A/YL-KTN/1020

A/YL-KTN/1020
回應規劃署的提問

回應運輸署的提問

消防裝置建議圖

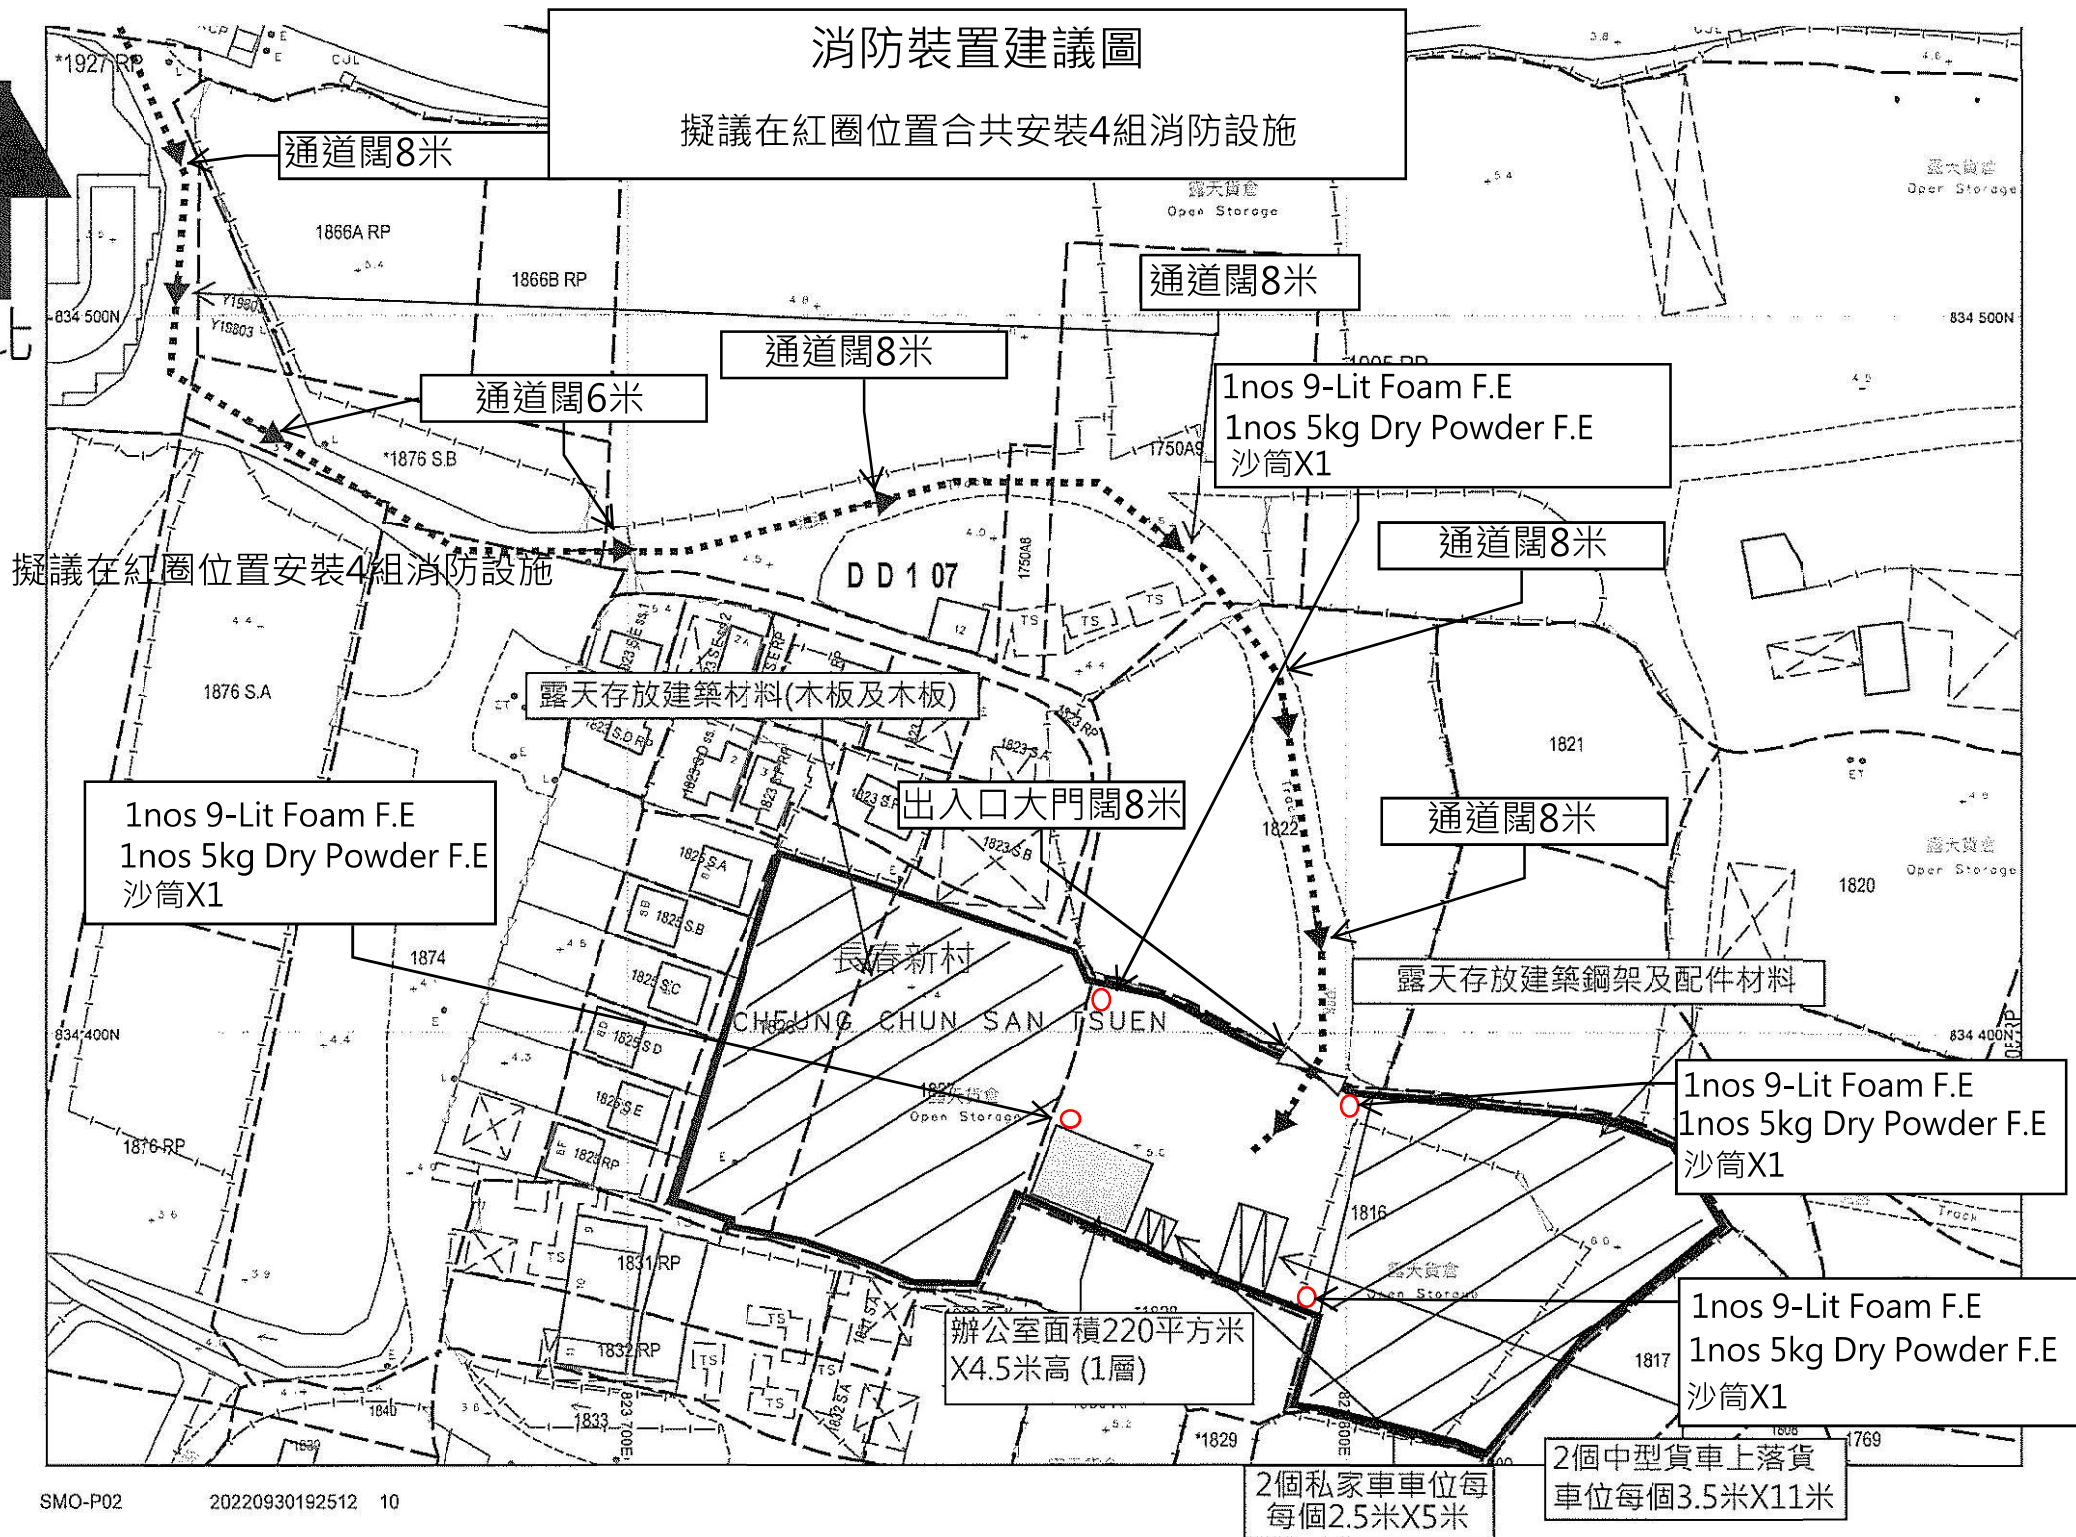
擬議在紅圈位置合共安裝4組消防設施

附圖相片 3

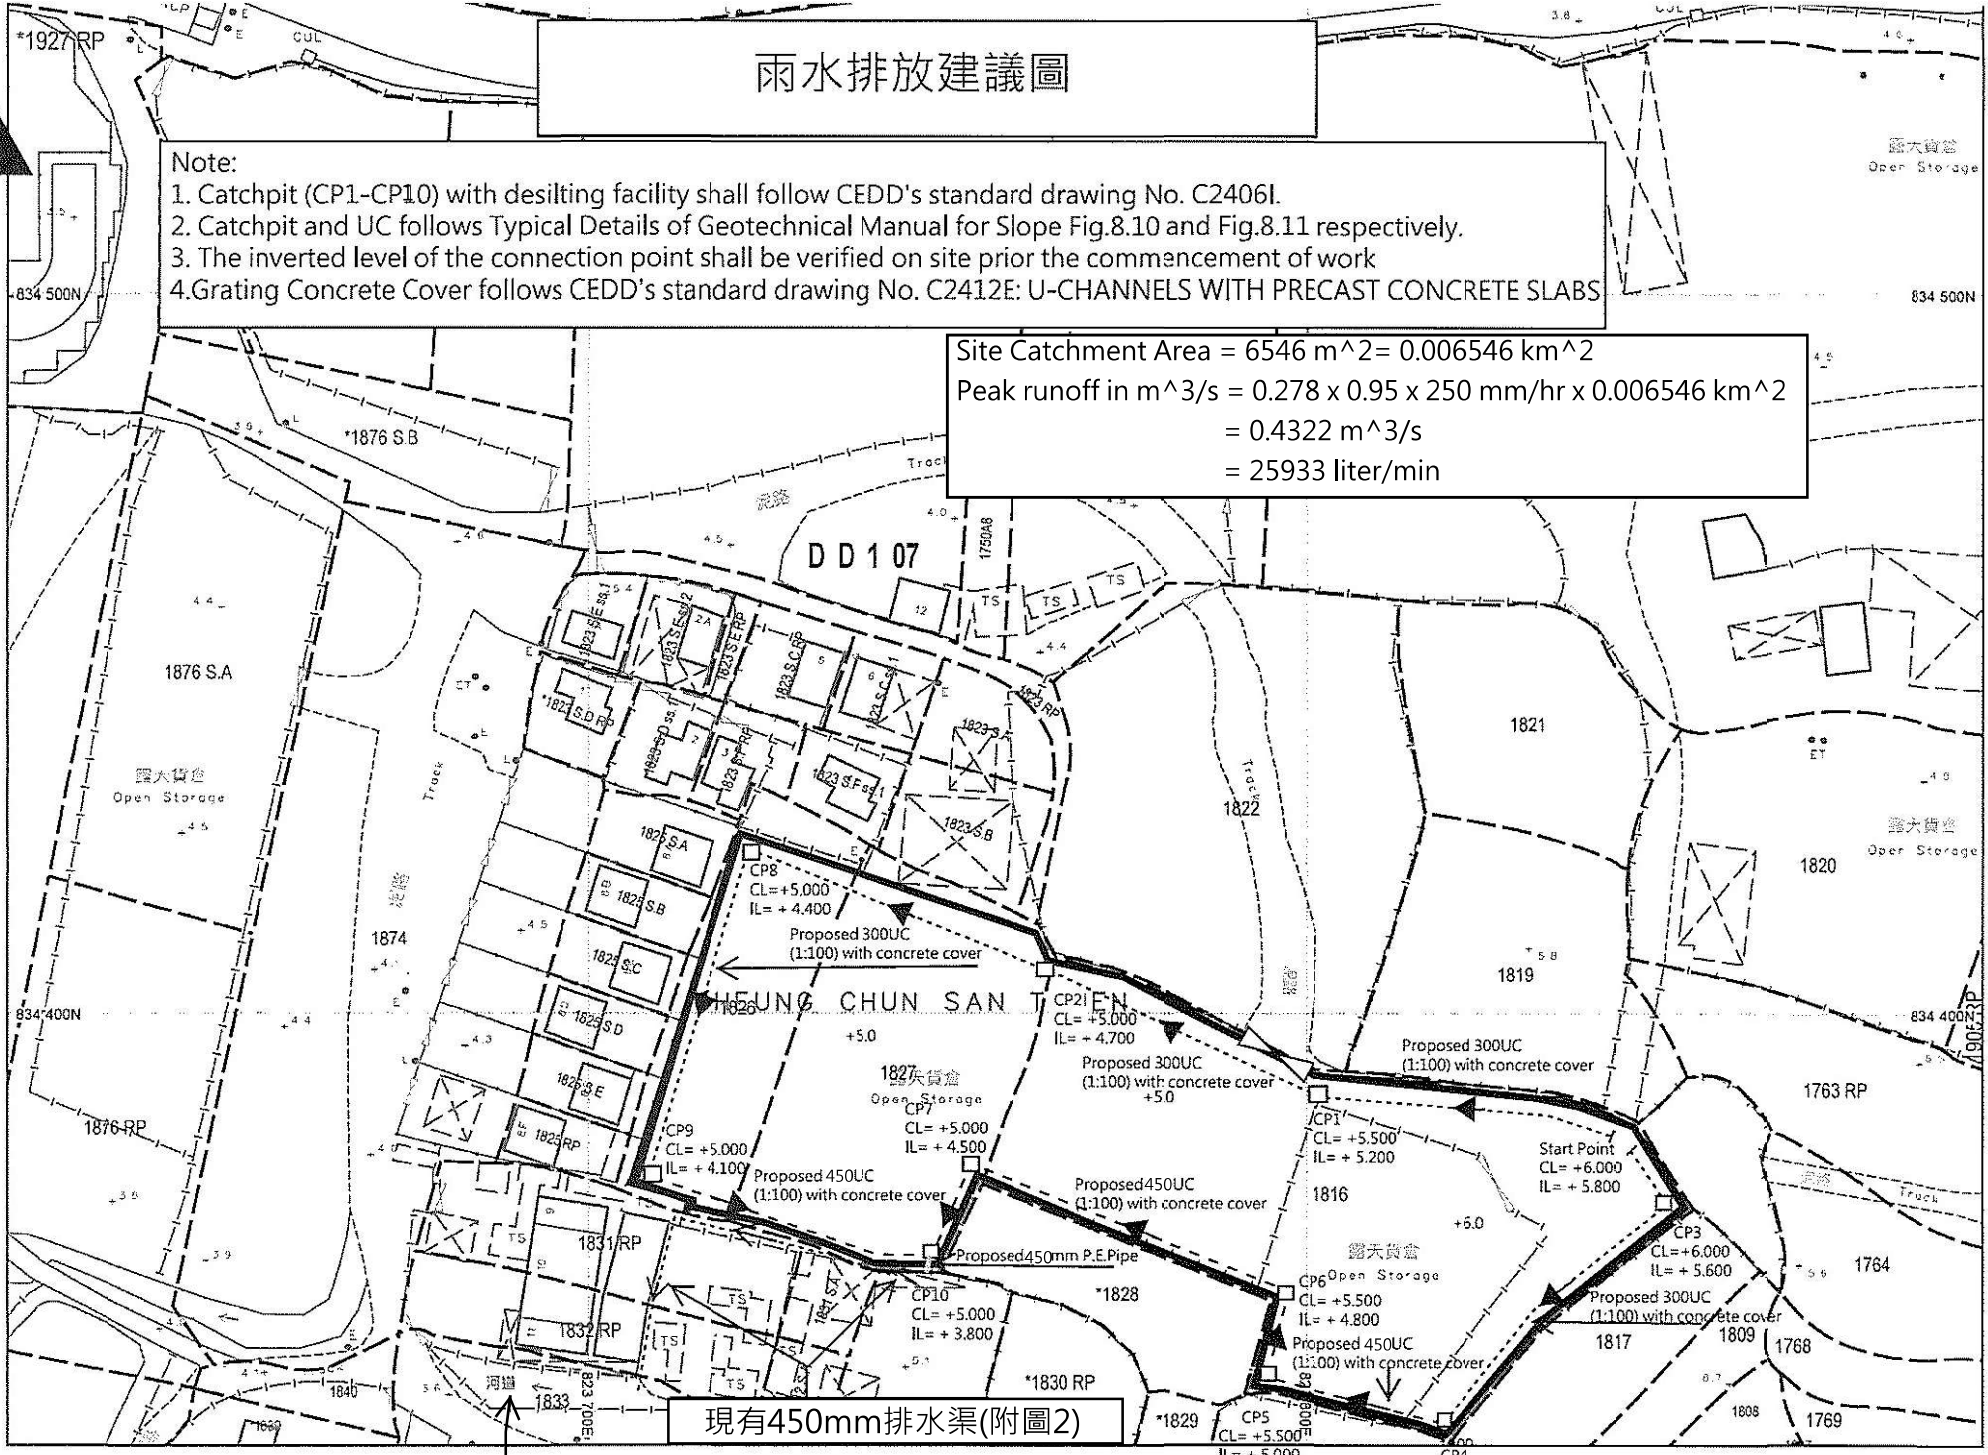
1. Viewing that the application site is in close proximity to residential dwellings, the applicant shall provide details of relevant mitigation measures to minimise the potential environmental nuisance in particular to the impacts of dust and noise to the surrounding environment;

有關申請地點西北面的住宅大部份閒置多時，主要為地產商多年前已購入大部份業權，之後一直空置，因上述地段為綜合發展區(1)等待日後發展，因此發展商沒有將上址出租，現場現時為十室九空的，(請看附圖相片 1)，我等會在西北面加設圍板及現時場地與村屋之間已有大樹分隔，因此對環境的影響非常輕微。(請看附圖相片 2)
2. The applicant shall provide details on types/substances of the 'wooden boards/metal frames/accessory materials' to be stored as well as the maximum height of any stacked-up materials at the application site; and

我等存放的物料為木板，木板，鋼通樑，及貨櫃箱改裝的臨時辦公室和儲物室，存放高度約為 5 米高(請看附圖相片 3)
3. The applicant shall clarify whether any workshop activities or operation of machineries will be carried out at the application site.

雨水排放建議圖

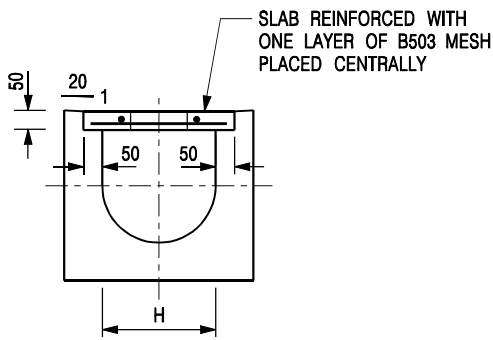
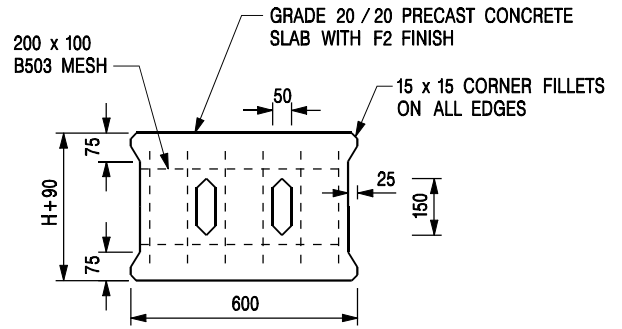
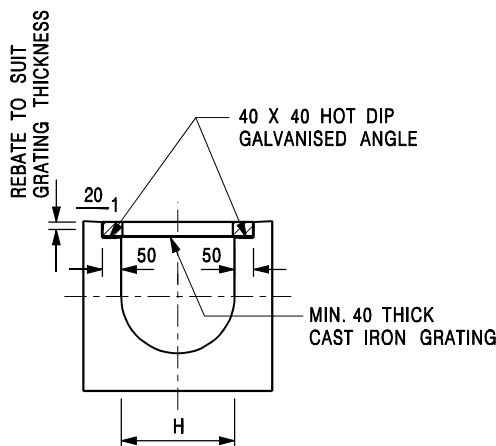
- (b) Please demonstrate with hydraulic calculations, with catchment plan, that all proposed/ existing drainage facilities are adequate to collect, convey and discharge the surface runoff accrued on the application site and to intercept the overland flow from the adjacent lands. 我等附上新一份排水建議圖內詳列有關計算及排水方案給貴署審議。

- (c) Please submit calculation demonstrating the downstream drainage system receiving the discharge from the development has adequate spare capacity to accommodate the runoff. 我等附上新一份排水建議圖內詳列有關計算及排水方案給貴署審議。

- (d) The proposal should indicate how the runoff (the flow direction) within the site would be discharged to the proposed u-channel. 我等附上新一份排水建議圖內詳列有關計算及排水方案給貴署審議。

- (j) Standard details should be provided to indicate the sectional details of the proposed u-channel and the catchpit. 我等附上新一份排水建議圖內詳列有關計算及排水方案給貴署審議。
- (k) Sand trap or provision alike should be provided before the collected runoff is discharged to the public drainage facilities. 我等設計的沙井全部設有沙坑。

Site Catchment Area = 6546 m² = 0.006546 km²
 Peak runoff in m³/s = 0.278 x 0.95 x 250 mm/hr x 0.006546 km²
 = 0.4322 m³/s
 = 25933 liter/min

A/YL-TKN/1020橫切面圖

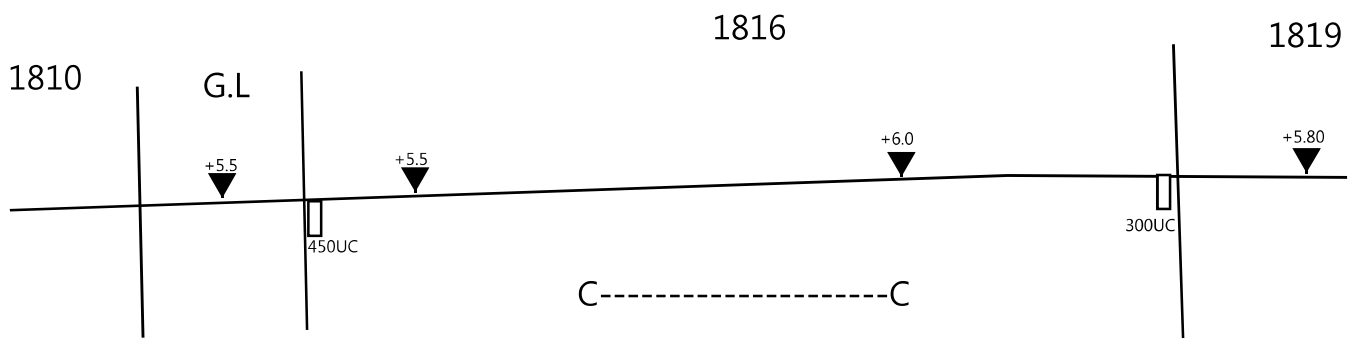
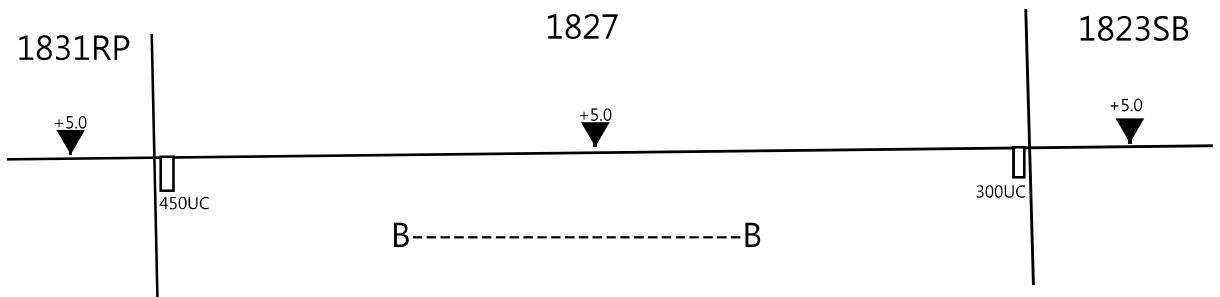
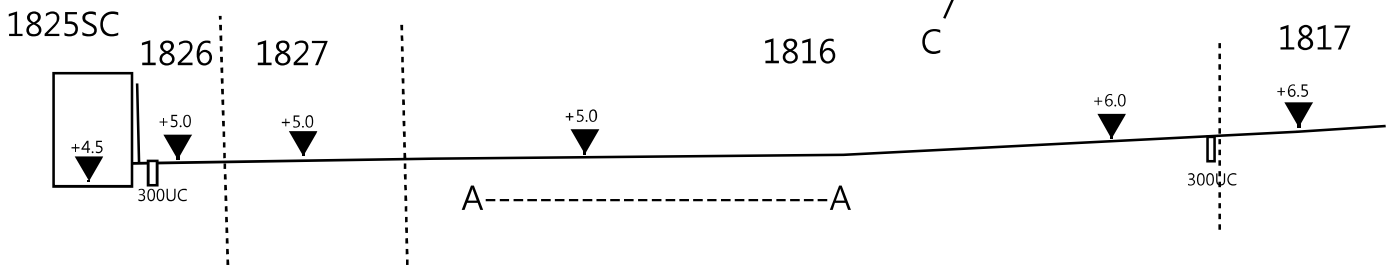
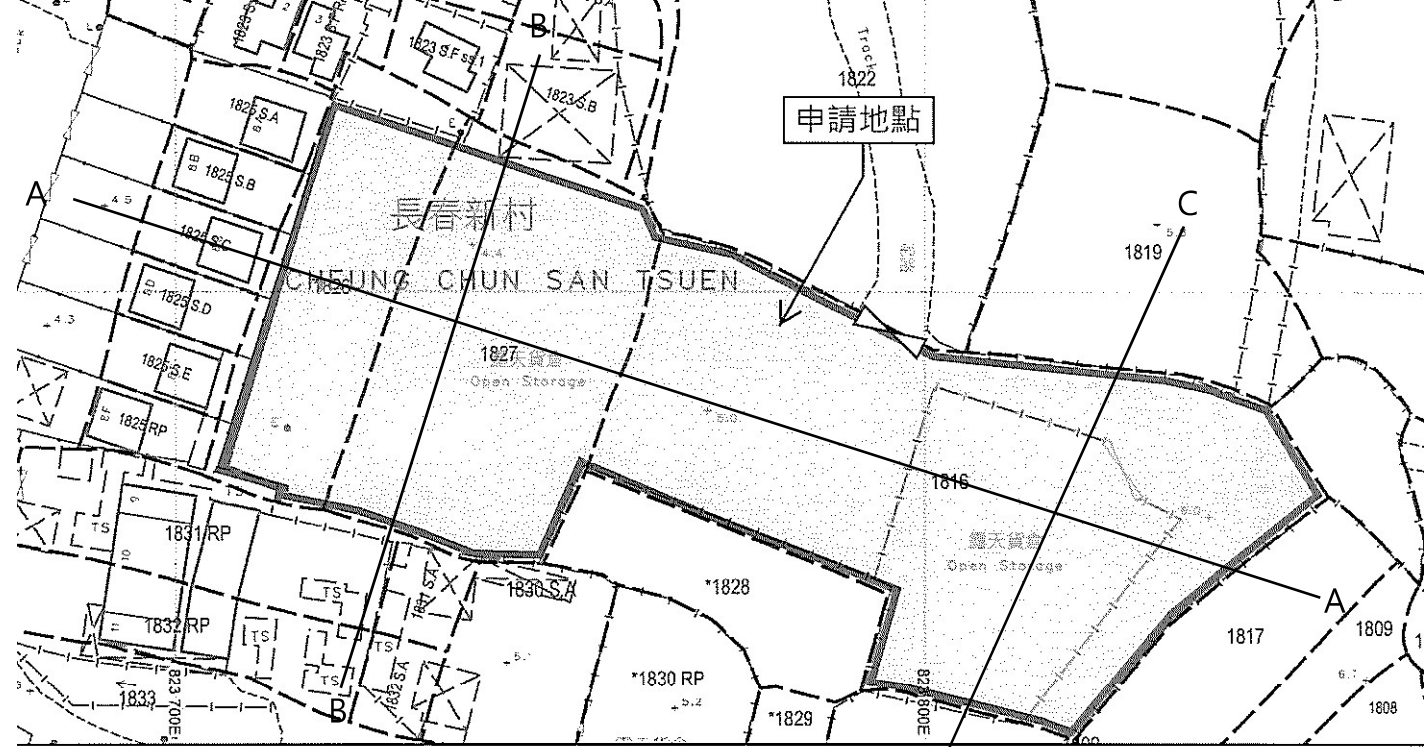
- (i) Cross sections showing the existing and proposed ground levels of the captioned site with respect to the adjacent areas should be given. 我等會連同此函一並附上橫切面圖給貴署參考
